# Access Compliance Report

### (Curb Ramps)

Intersection ID: 10021684	Main Street: BRAY_DR	Cross Street: N/A	Location: SW
ADA ID: AF766AB9F0B7	Ramp Type: Perp	Initial Pass/Fail: Fail	Overall Compliance: No
Severity Score: 21.25			
Codes/Mitigation Info/Possible Solution		Field Measurements/Component Compliance

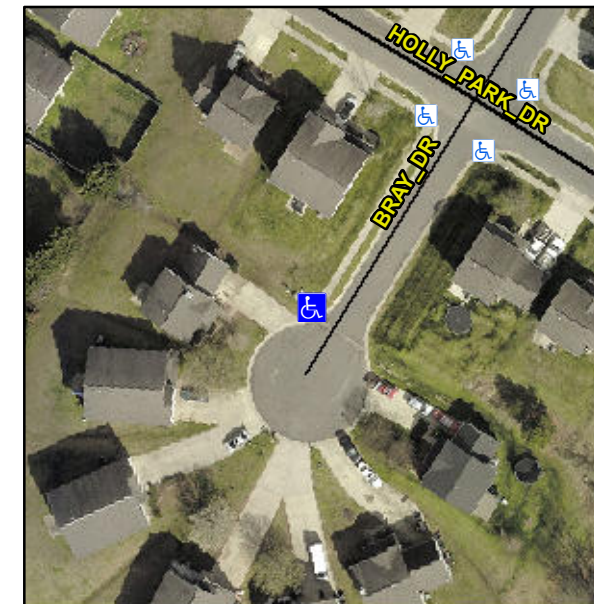
**Remove & Replace Entire Ramp.**

**R304.5.1, R304.5.3**
